NOTICE OF ALLOWANCE AND FEE(S) DUE

APPLICATION NO.	FILING DATE	FIRST NAMED INVENTOR	ATTORNEY DOCKET NO.	CONFIRMATION NO.
17/989,156	11/17/2022	MICHAEL PRATT	P-00294	9468

TITLE OF INVENTION: RAPID-ENTRY SHOE

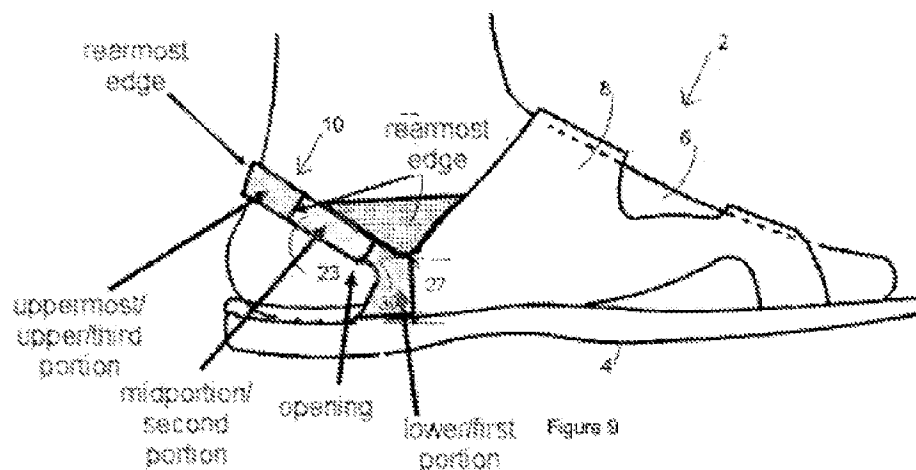
In the Office Action, the Examiner equates various portions of the heel restraint and heel strap disclosed in Somerville to the lower portion, the midportion and the upper portion of

Applicant's heel structure. The Examiner's interpretation of Sommerville's heel restraint and heel strap, originally provide in the Office Action, is reproduced as annotated FIG. 9 below.

In annotated FIG. 9, the Examiner equates the neck portion 30 (referred to in annotated FIG. 9 as the “lower/first portion”) of Sommerville’s heel restraint 10 to the lower portion of claim 1. While Applicant disagrees with the Examiner’s interpretation, claim 1 has been amended to recite that the lower portion extends “around the rear portion of the upper between the medial side of the rapid-entry shoe and the lateral side of the rapid-entry shoe.”

Figure 10

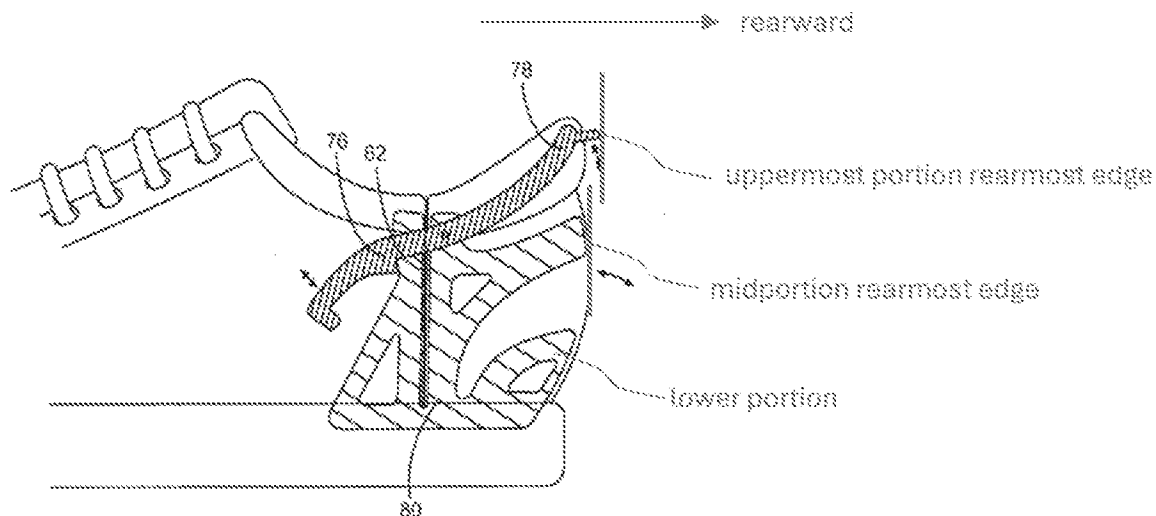
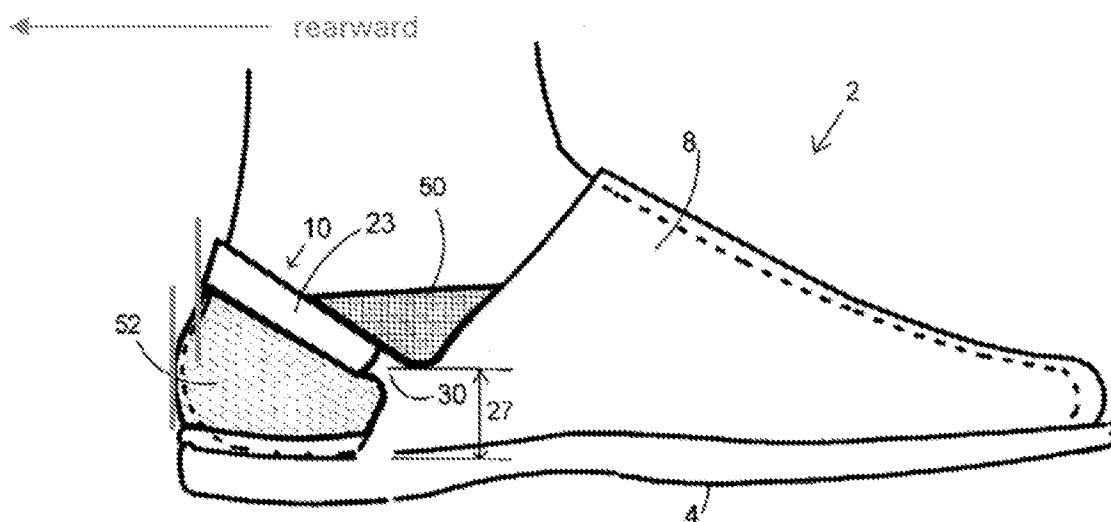
Sommerville does not disclose or suggest all of the above-recited features of claim 1. For example, assuming, *arguendo*, the Examiner were to compare Applicant’s heel structure to the combination of the heel strap 23 and the heel cover 52 in Figure 10 of Somerville, the rearmost edge of heel strap 23 of Somerville does not “extend[s] rearward further” than the rearmost edge of heel cover 52 of Somerville. See below, annotated Figure 29 of the present application and Figure 10 of Somerville.

Figure 10

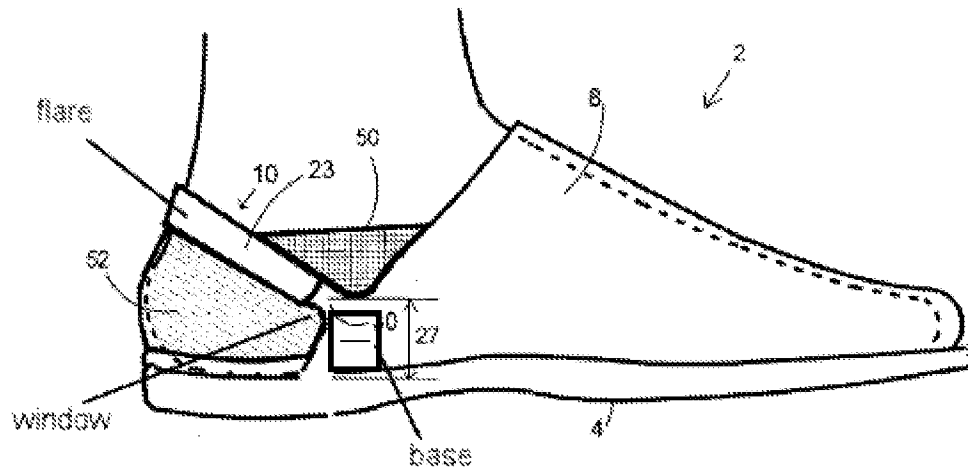
Regarding claim 1, Somerville discloses a rapid-entry shoe comprising: a sole (4); an upper (8, 52) at least partially comprising a flexible material (50); and a heel structure (10) contained within a rear portion of the upper, the heel structure extending from the sole portion and comprising: a base (lower rear portion of vamp 8, as seen in annotated Fig. 10) extending between a medial side and a lateral side of the rapid-entry shoe; and a flare (23) extending upward and rearward from a rear, top portion of the base between the medial side of and the lateral side of the rapid-entry shoe, wherein at least a portion of the rapid-entry shoe at least partially pivots about an axis (18) and causes the flexible material to

expand in response to a downward force applied to the flare (as seen in Fig. 8) (paragraphs 0042, 0044, 0047, 0049, 0051, 0056-0057; Fig. 8-10).

structure comprising: a base (lower rear portion of vamp 8, as seen in annotated Fig. 10); and a flare (23) extending rearward and upward from a top portion of the base, the flare causing the heel structure to at least partially pivot about an axis of rotation proximal to the sole in response to a foot being inserted into the opening of the rapid-entry shoe (Fig. 8) and causing the upper transition from a first state to an expanded state (Fig. 8) is response to the foot being inserted into the opening of the rapid-entry shoe (paragraphs 0042, 0044, 0047, 0049, 0051, 0056-0057; Fig. 8-10).

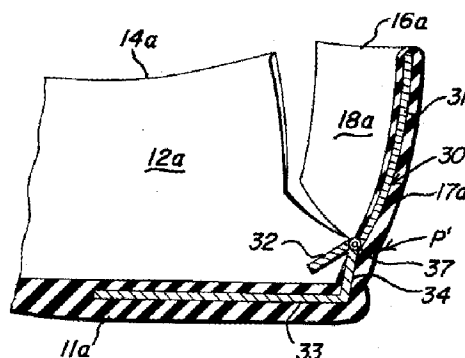
In the Office Action, the Examiner points to the rigid bracket 30 of FIG. 6 (included below for the Examiner's convenience) as being equivalent to the claimed flare. Applicant respectfully disagrees.

As shown in FIG. 6 of Owings, the rigid bracket 30 does not extend “upward and back” from a body portion of a heel structure as required in the claim. Additionally, Applicant submits that Owings does not disclose or suggest that a downward force can be applied to the rigid bracket, let alone that the downward force would cause “at least a portion of the rapid-entry shoe [to] at least partially [pivot] about an axis” as required by the claim. Further, Applicant submits that the rigid bracket 30 does not cause a “flexible material to expand” as is also required by the claim.

Indeed, according to Owings, the overshoe shown in FIG. 6 does not expand at all. For example, Owings states “By providing a hinged section which *is normally biased to an open position*, the opening through which a shoe must be inserted is *sufficiently enlarged to eliminate any stretching of the wall*. Thus, the wearer does not reach down to grasp the overshoe wall, but merely steps into the overshoe. When the heel of the shoe reaches the surface of the heel portion of the sole, *the heel section will be pivoted to the closed position* by the lever means to provide the necessary clamping force for maintaining the overshoe in the proper position.” (Owings, col. 6, liens 6-16, emphasis added).
